RIVERSIDE TERRACE CONDO.
Elevator Survey & Report
April 17, 2025

Prepared by
Carey & Associates, Inc.

Prepared for:
Riverside Terrace Condominium Association, Inc.
615 N. Riverside Drive
Pompano Beach, FL 33062

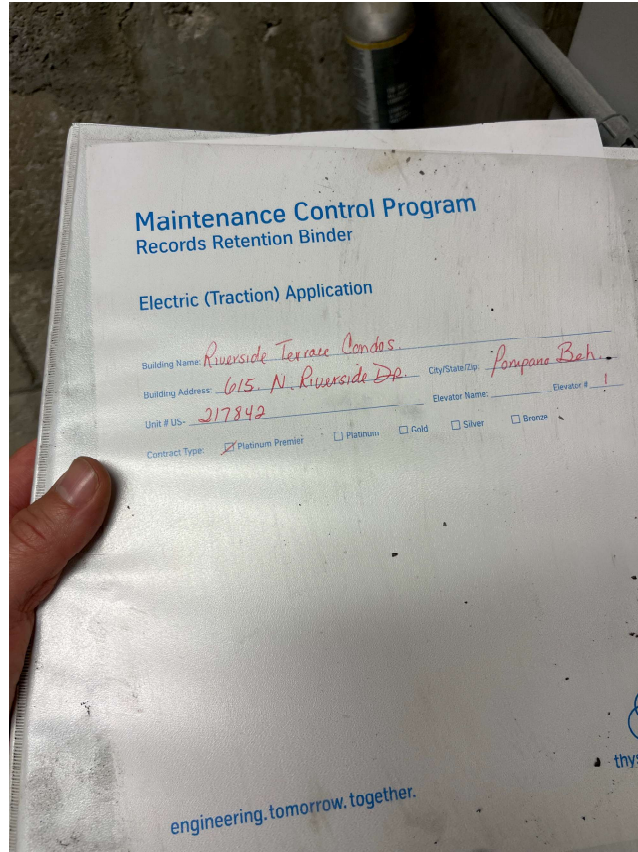
Maintenance check chart indicates only one service visit in 2023.

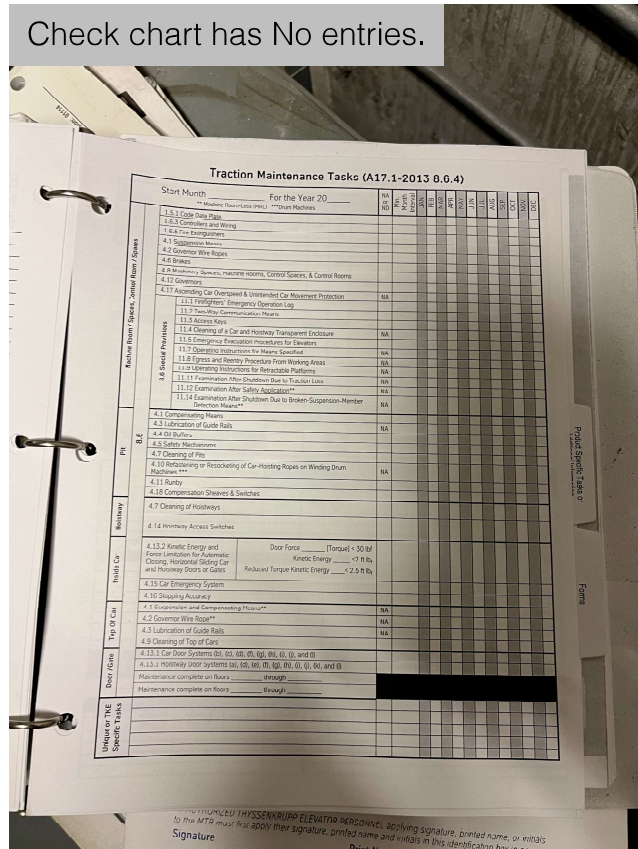
Check chart has No entries.

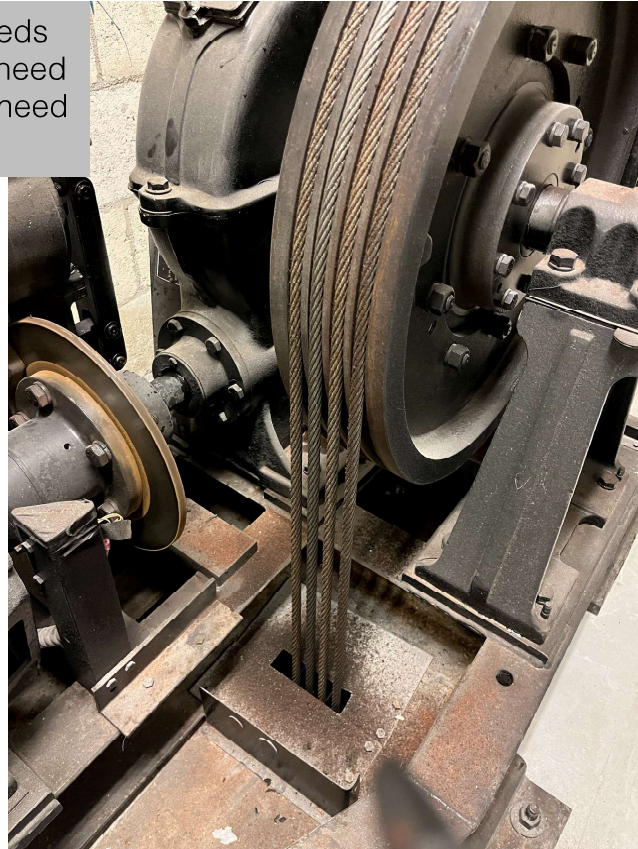
The elevator machine needs cleaning. The hoist ropes need cleaning and the grooves need to be cleaned up.

The Governor needs cleaning and lubrication.

Machine needs cleaning to remove dust build up.

Machine needs cleaning to remove dust build up.

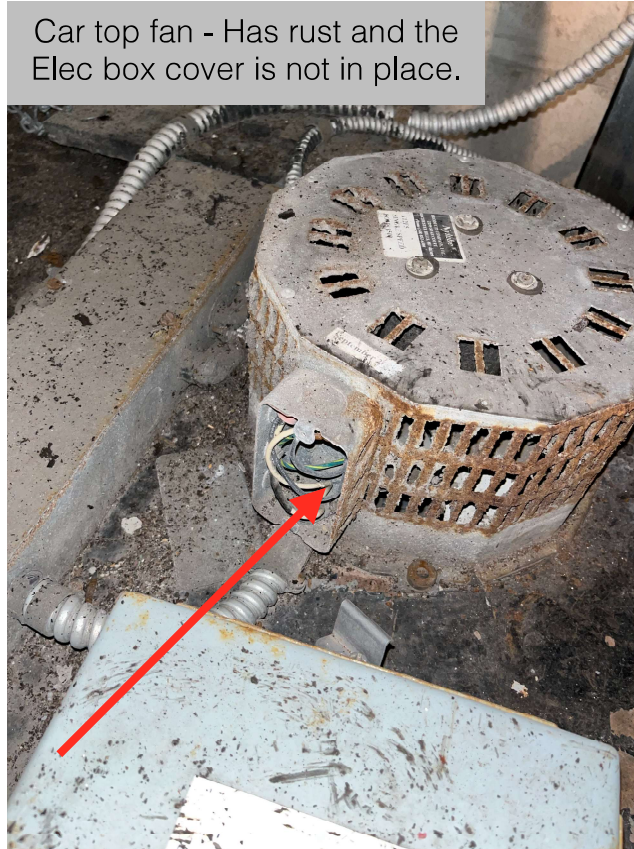
Car top roller guides need cleaning and lubrication.

Selector tape is stainless steel and in good condition.

Car top fan - Has rust and the Elec box cover is not in place.

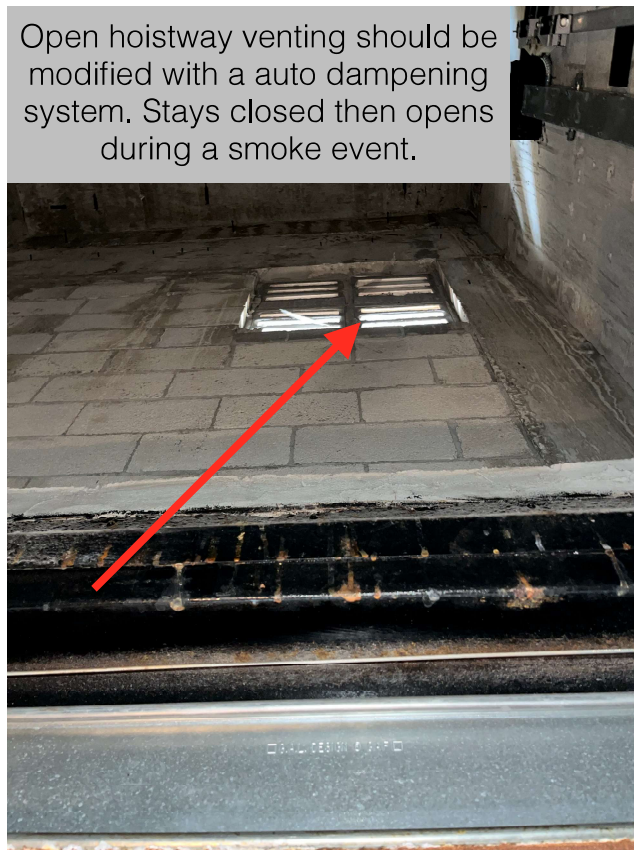
Open hoistway venting should be modified with a auto dampening system. Stays closed then opens during a smoke event.

This is a GAL water resistant door operator. It needs cleaning and lubrication.

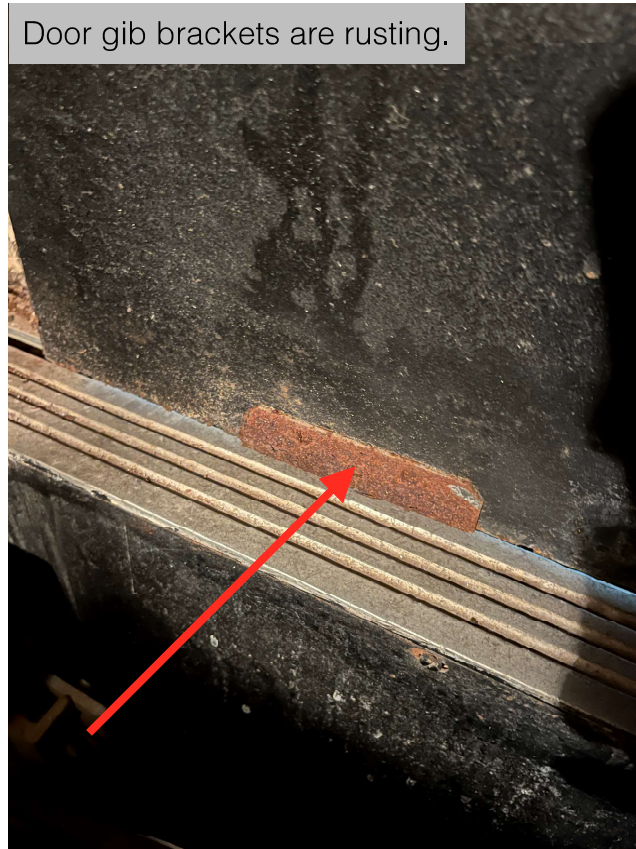
This is a GAL water resistant door operator. It needs cleaning and lubrication.

Hoistway door track and hardware needs cleaning and lubrication.

Door gib brackets are rusting.

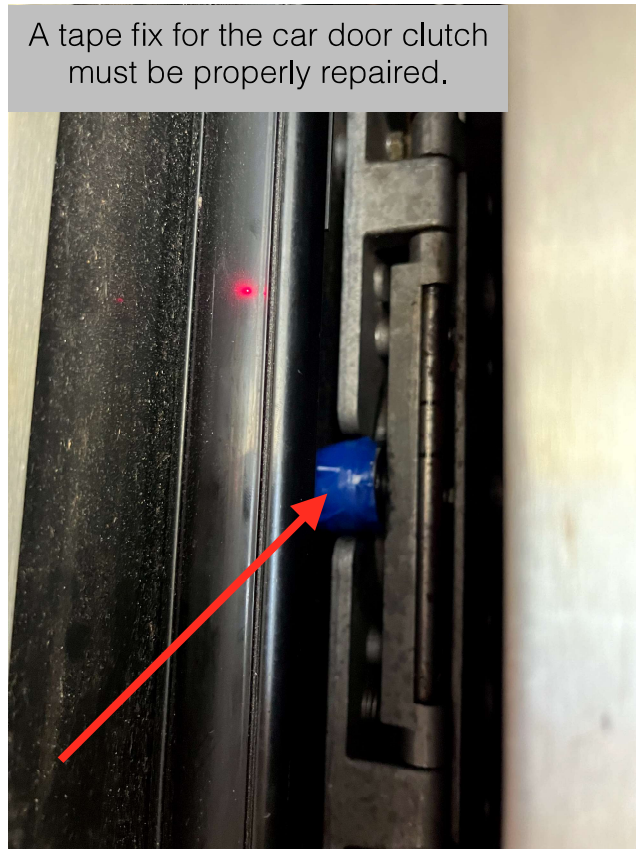
A tape fix for the car door clutch must be properly repaired.

Rear Door at Lobby level.

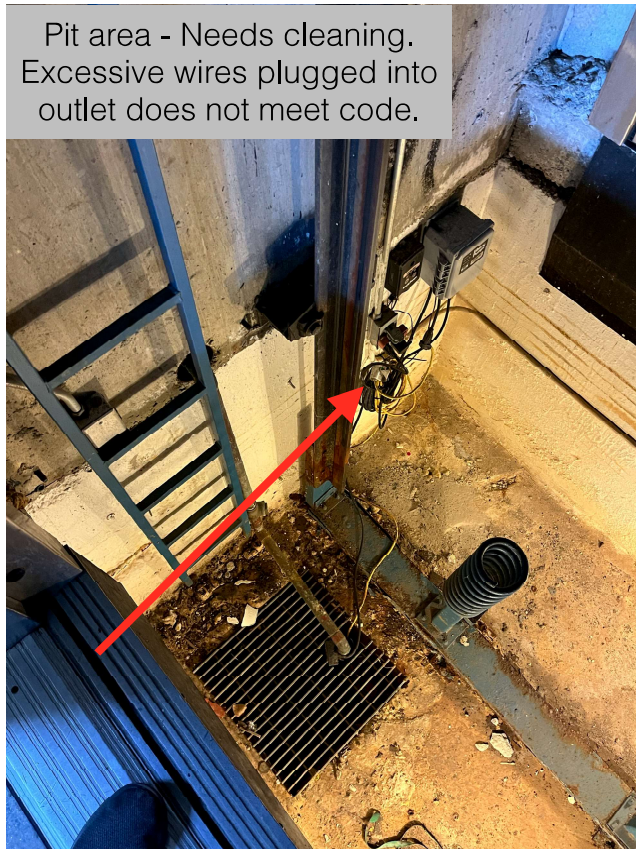
Pit area - Needs cleaning.
Excessive wires plugged into
outlet does not meet code.

Fascia appears to be missing.

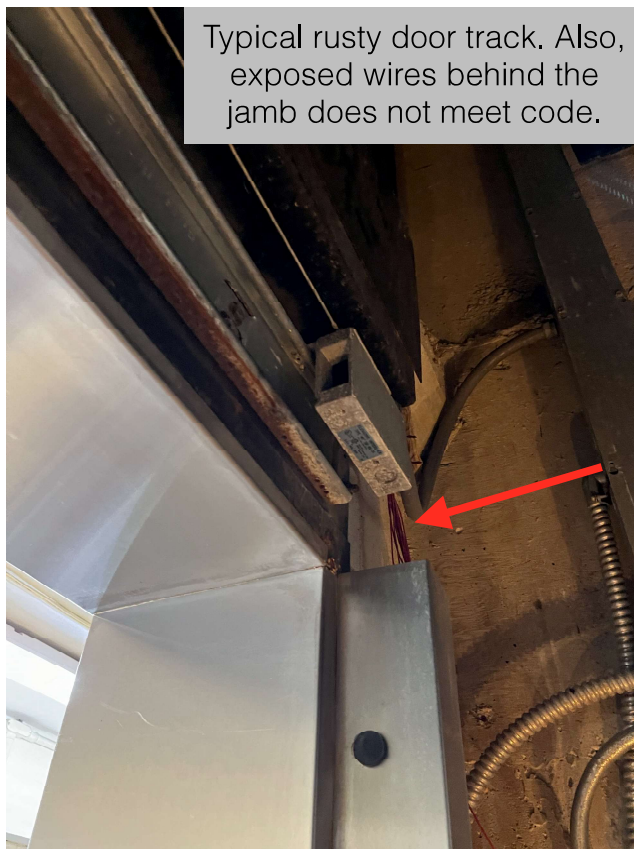
Typical rusty door track. Also, exposed wires behind the jamb does not meet code.

Kellum grip needs tape around bottom per manufacture.

Car safeties appear to be in good condition.
